ISSUE: Certificate of Appropriateness for new construction

APPLICANT: City of Alexandria and Washington Metropolitan Area Transit Authority (WMATA)

BAR#2019-00241
2901 Potomac Ave. (2405, 2501, and 3701 Potomac Ave., 3251 Potomac Ave.
[Parcel ID 016.04-01-01], 700 Carpenter Rd, 1702 & 1880 Potomac Greens Dr.)

**Contract No. FQ16146 - Washington Metropolitan Area Transit Authority
(WMATA) Potomac Yards Metrorail Station
LTR-0104-PM-City of Alexandria January 22nd, 2020 BAR Submission**

D2 - LOOKING WEST

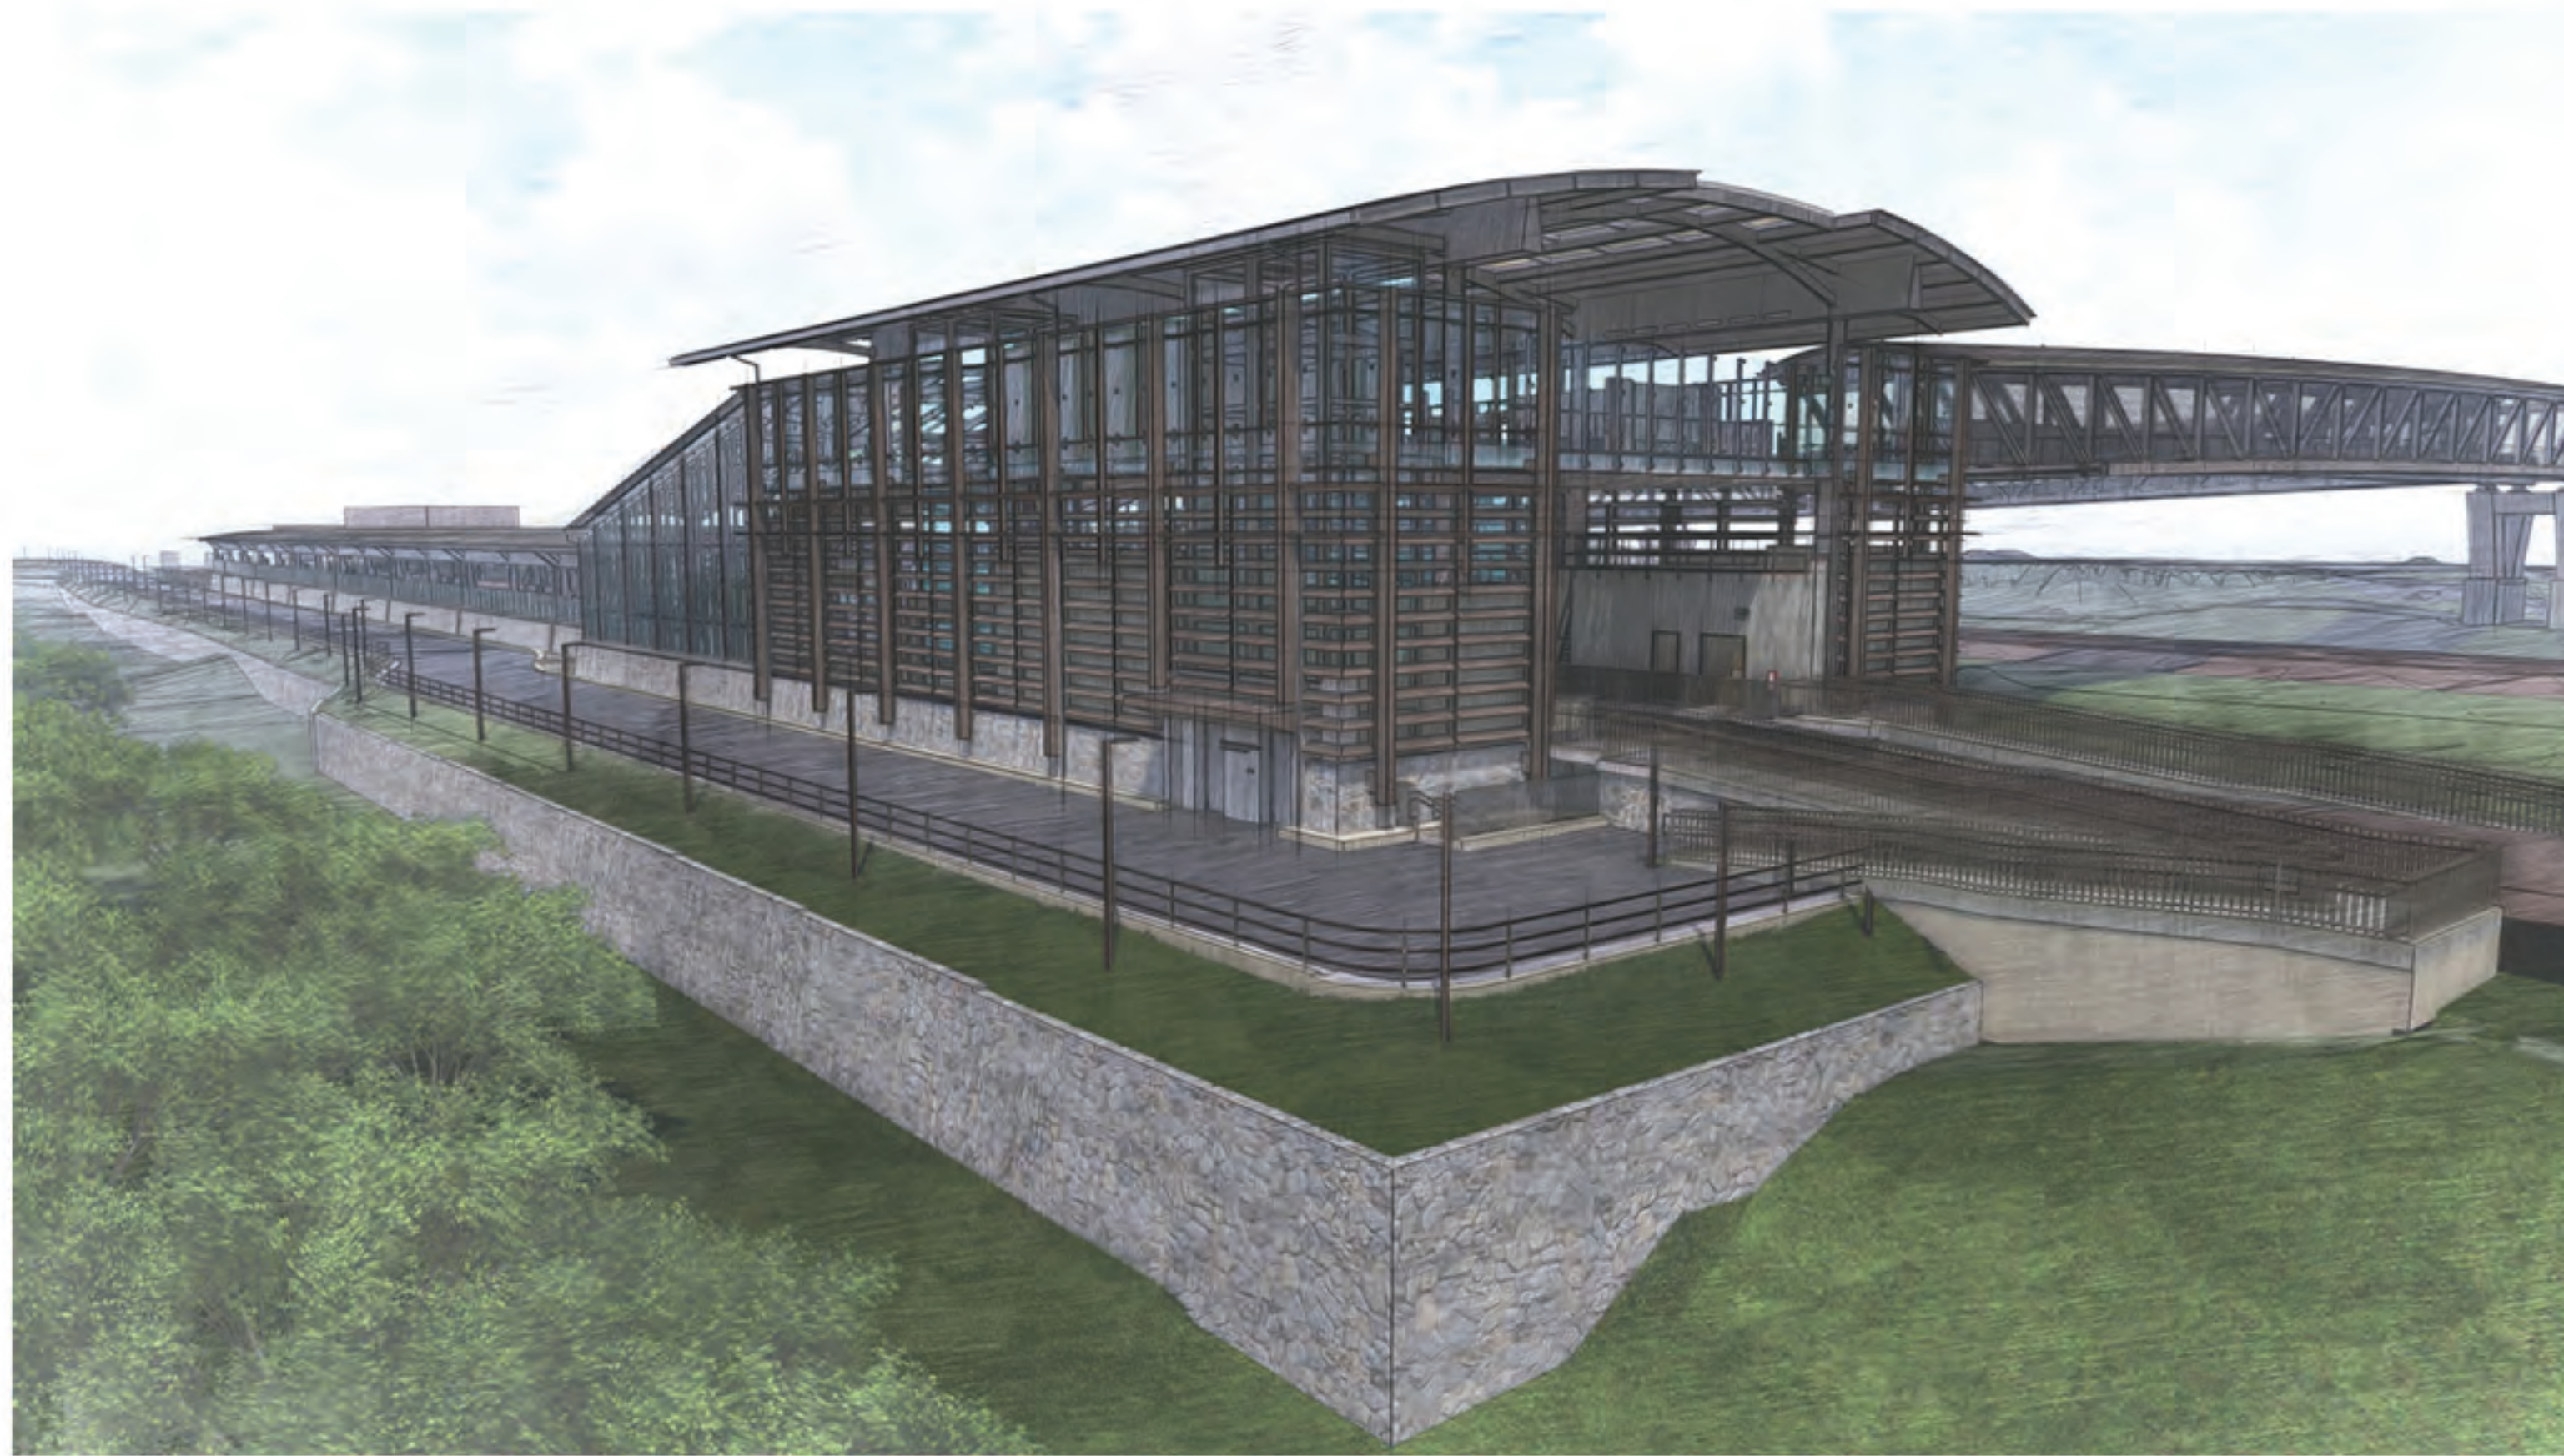
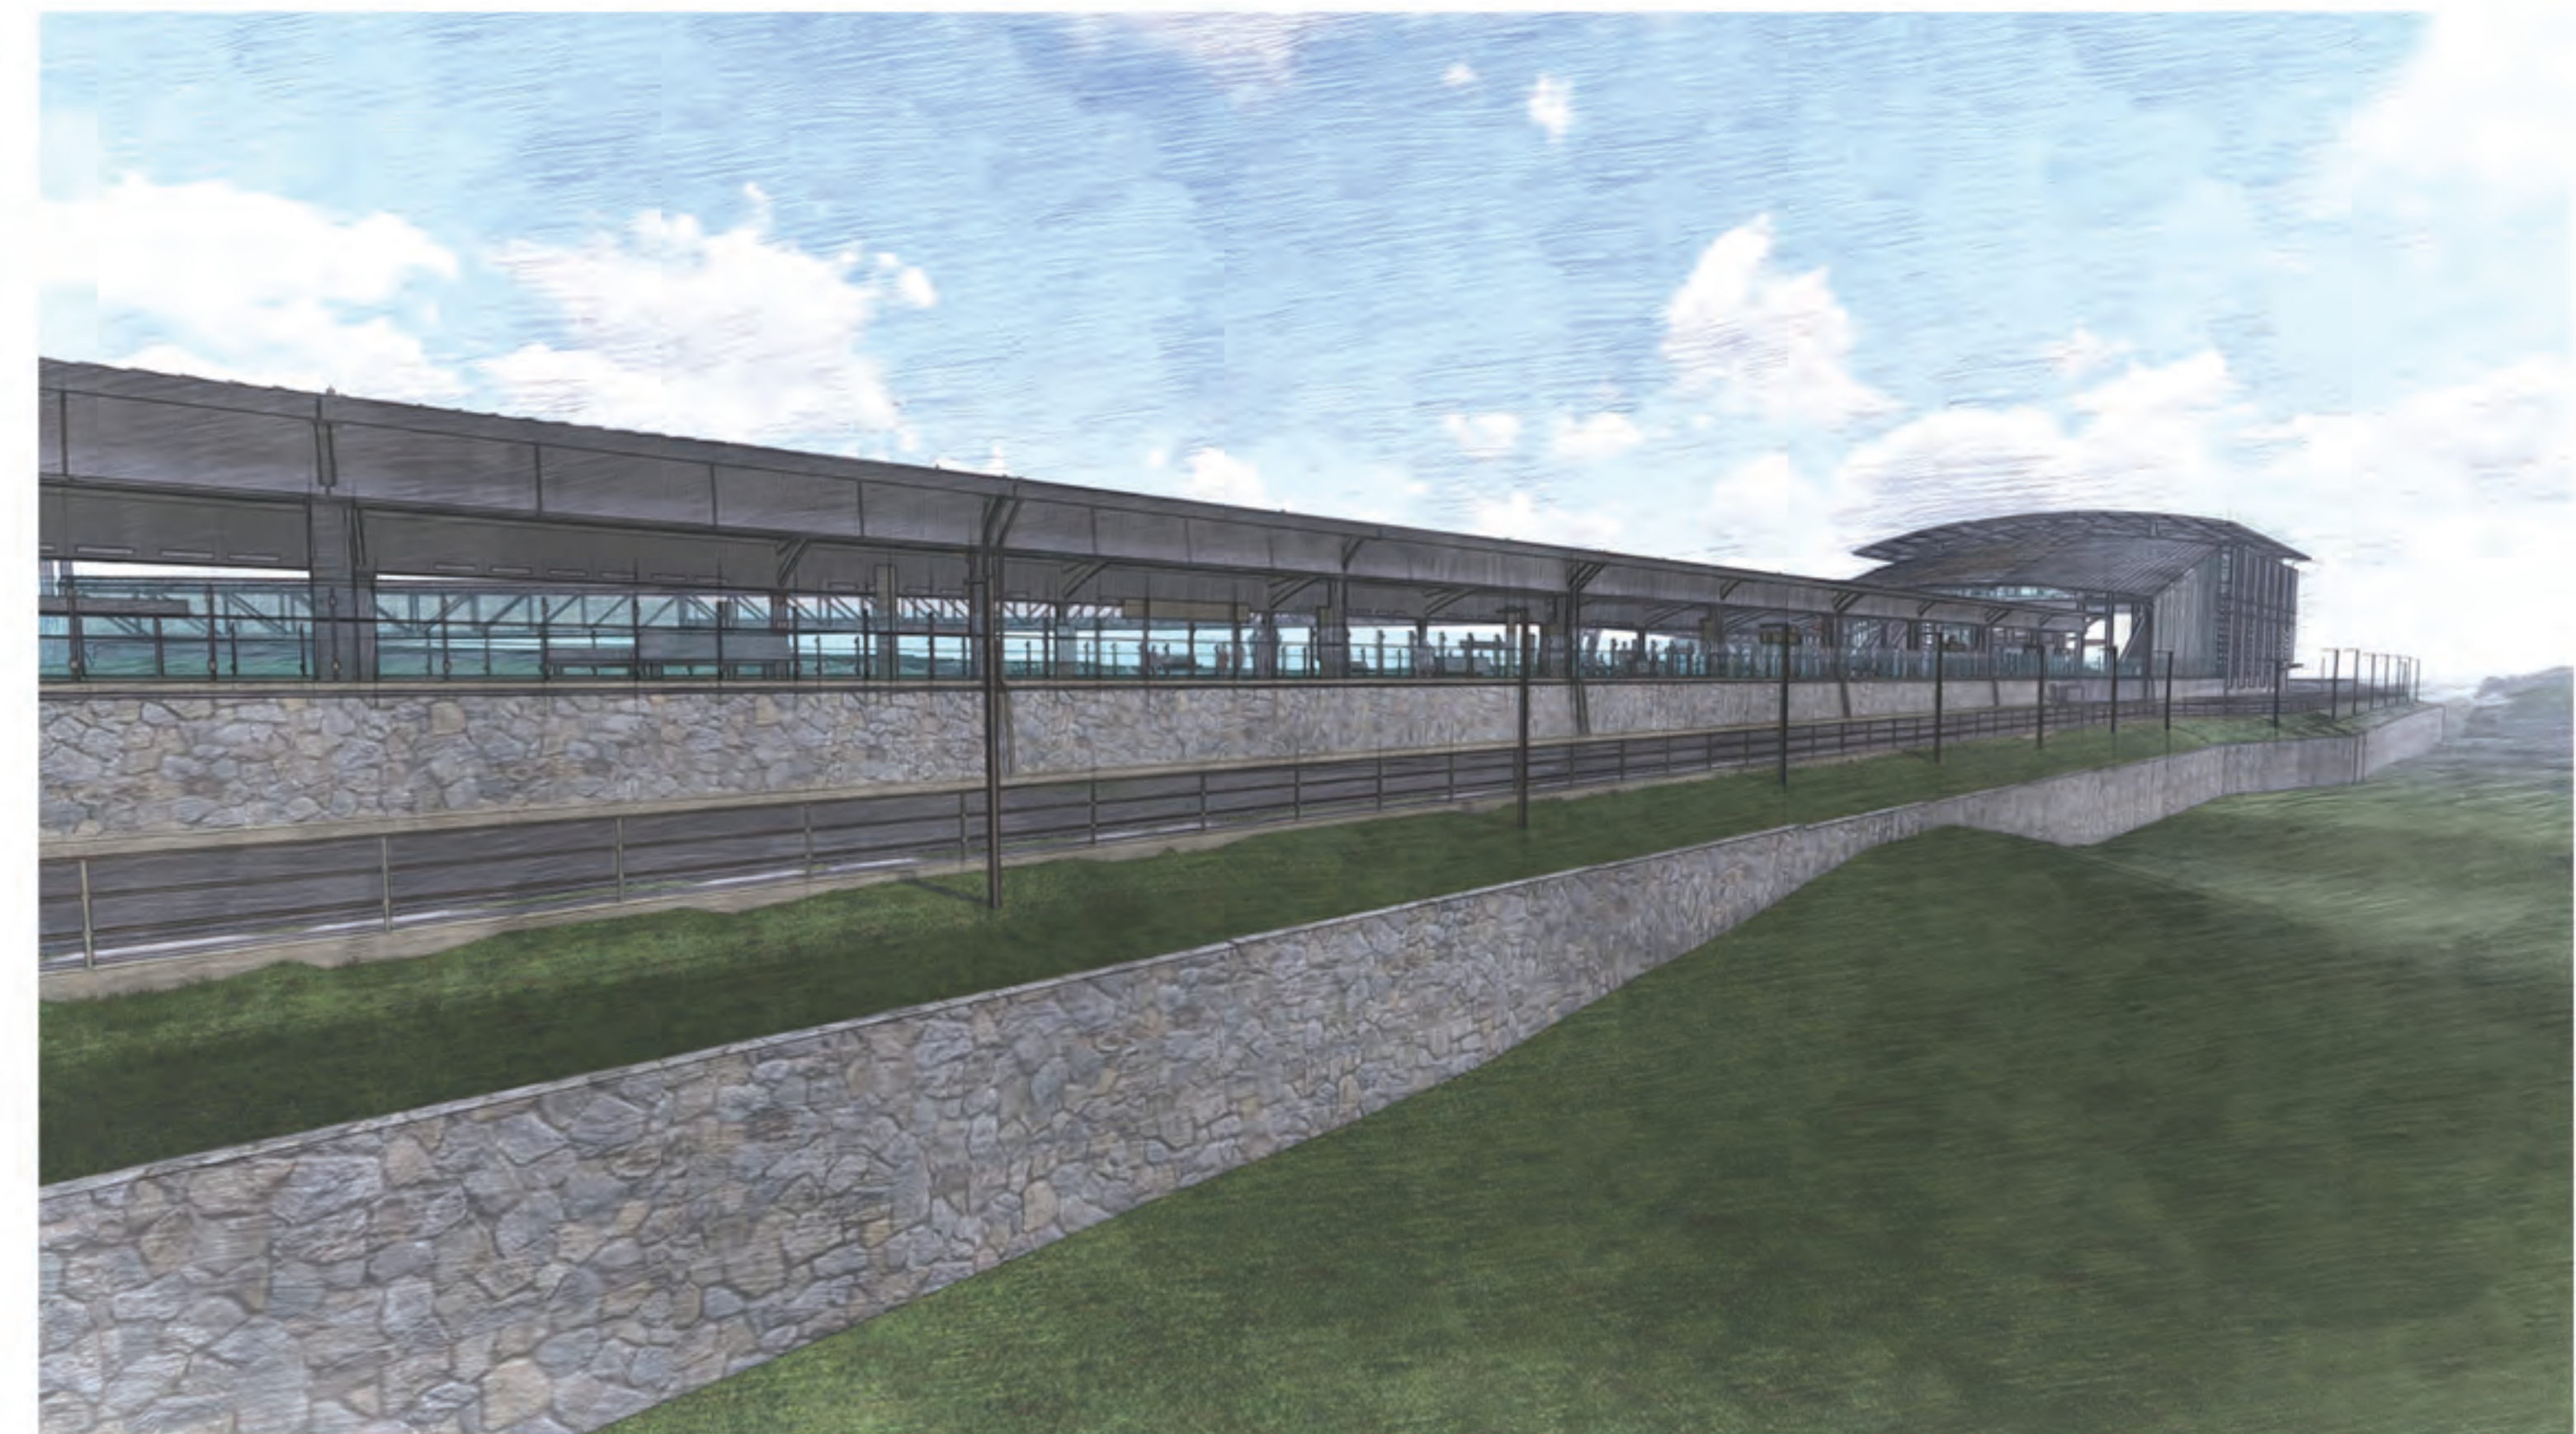
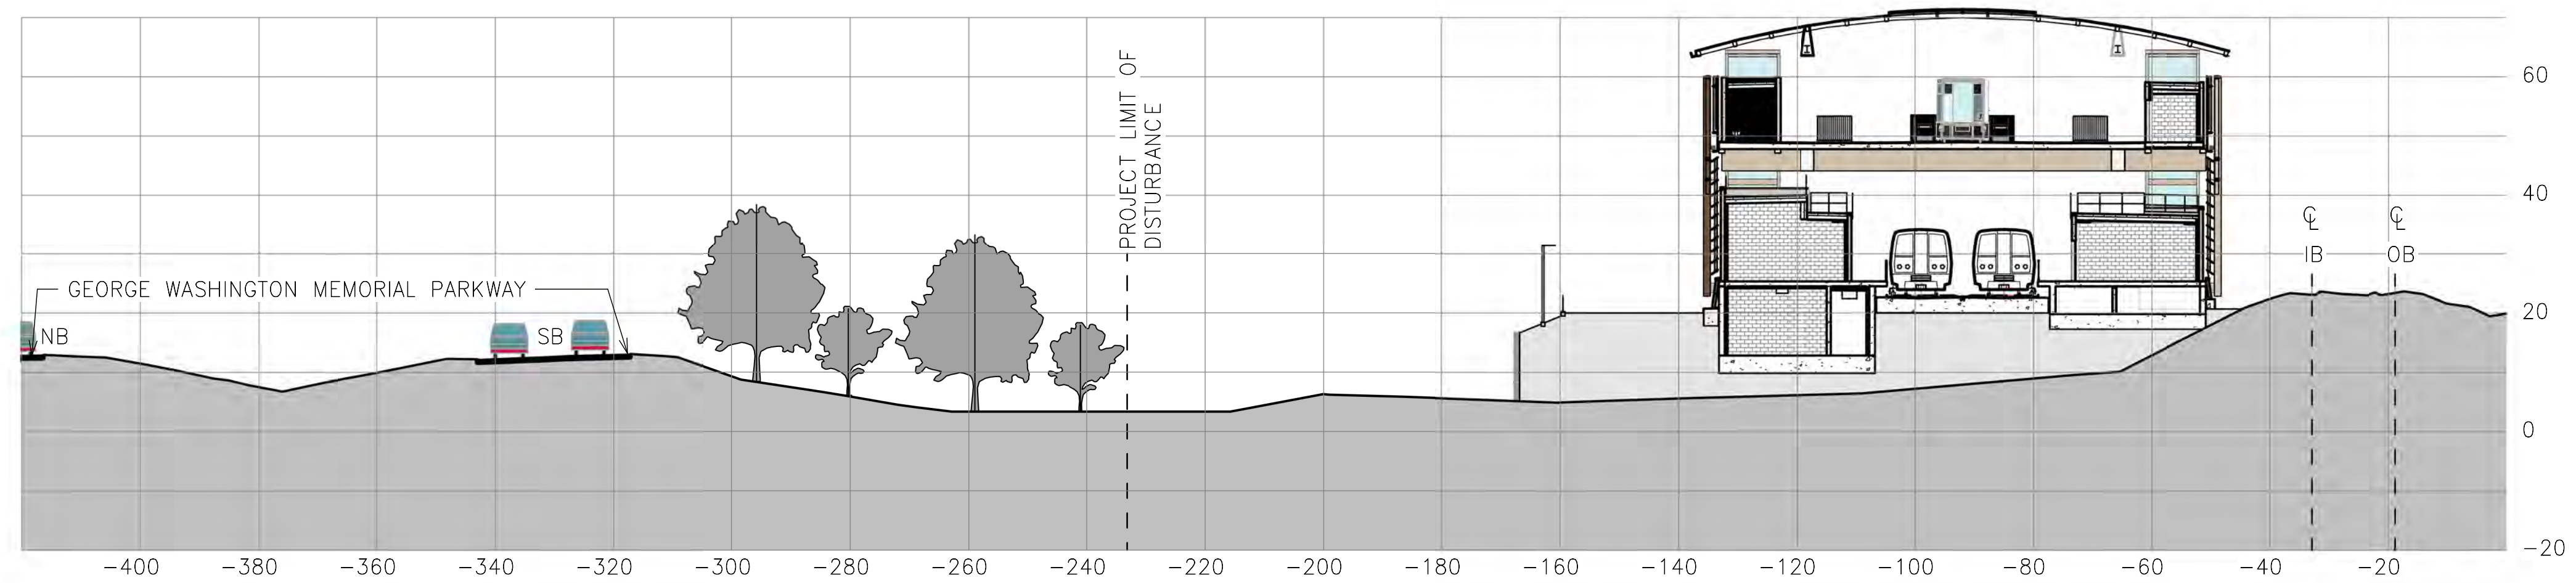
As noted above, the retaining wall design has changed as a result of extensive conversations with the National Park Service. Their landscape architects did not believe that the steep earth slope previously proposed would support native plants and would be an unsightly backdrop to the wetlands. Therefore, a vertical concrete retaining wall clad with fieldstone to match the plinth of the Metro station and historic GW Parkway infrastructure is being proposed. The height of the wall varies depending on the adjacent topography and there is an approximately four-foot wide earth berm at the top of the wall that will support plant material and contain the bases for the pole lights for the service road. Staff believes that the stone retaining wall is a far better solution than the earth berm and, although much of it will be hidden by the plant material in the wetland, it will be more attractive from the Parkway. It is also a safer edge condition for bicyclists and pedestrians on the station service road.

1. Approval of the downspout details with the color of the downspouts to match the adjacent structural feature and final review of the cover plate details by staff; the Chocolate Brown Met color flat exoskeleton finish; and the guardrail and stone retaining wall, as submitted.
2. Deferral of the cast stone details and west elevation of the entrance pavilion on the west side of the tracks, the glass handrail/guardrail details in the station and exoskeleton connection details.
